TECHNICAL BULLETIN

412-05-203

Revision B, 12 December 2016

SUBJECT: TAILBOOM BULKHEAD REINFORCEMENT

Figure 1

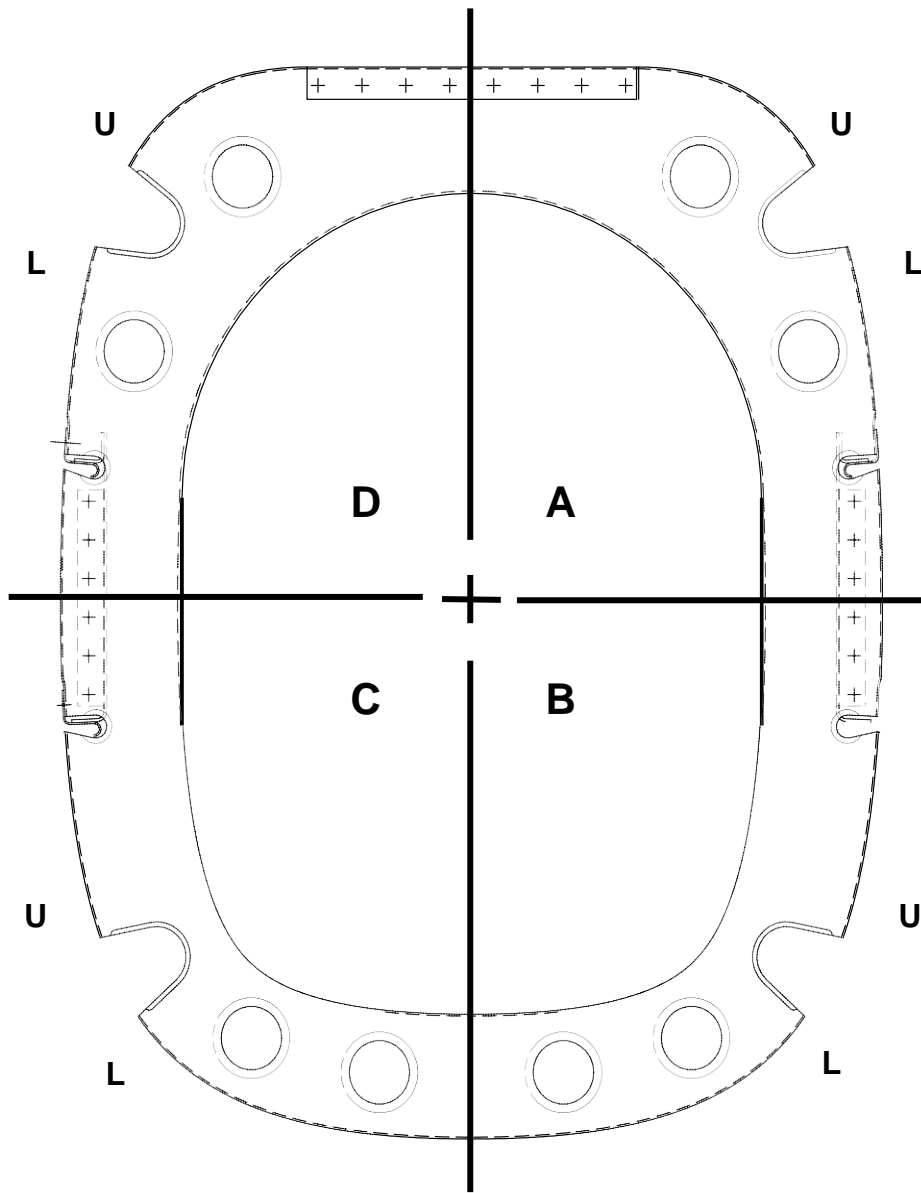
1. Prepare the helicopter for maintenance.
2. Remove the access panels at the tailboom lower surface to gain access to the bulkheads at STA 122.33, 143.28, 164.23, 185.18, and 194.30.
3. Select the proper doubler for the location ([Figure 1](#)) and remove the existing rivets common to the outside skin in the area covered by the doubler. Note rivet size, type, and location for reinstallation.

Figure 2

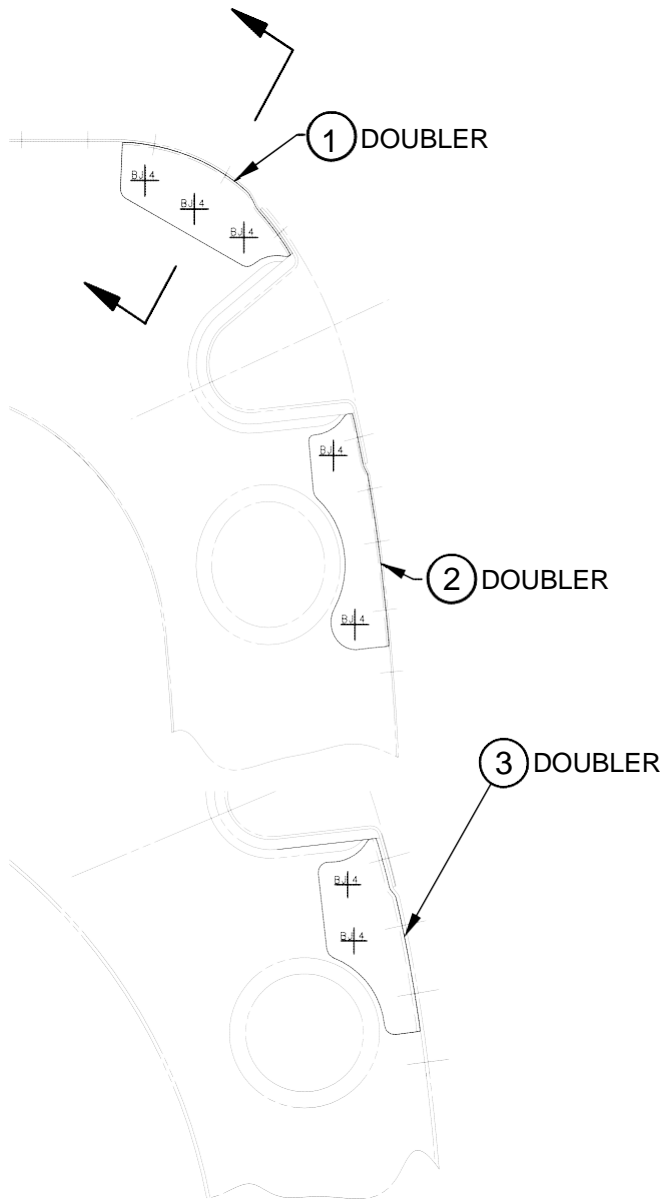
5. Position the doubler selected in step 3 and transfer the existing rivet holes. Attach with Clecos. Mark for two or three additional rivet holes, depending on the location, through the doubler and the existing bulkhead, as shown in [Figure 2](#). Remove the doubler and deburr all the parts.

6. Lightly sand the faying surfaces and apply adhesive (C-317). Attach the doubler with existing-type rivets of appropriate length. All new rivets are MS20470AD4 rivets. Remove excess adhesive squeeze out and allow to dry
7. Seal the doubler edges with sealant (C-392) and apply a coat of primer (C-204).
8. Repeat step 3 through step 7 for all other applicable locations.
9. Reinstall the access panels at the lower surface of the tailboom.
10. Prepare the helicopter for flight.
11. Make an entry in the helicopter logbook and historical service records indicating compliance with this Technical Bulletin.

Note: Shape and size of doublers may vary. Maintain 2D edge distance on end fasteners. Fastener pattern typical
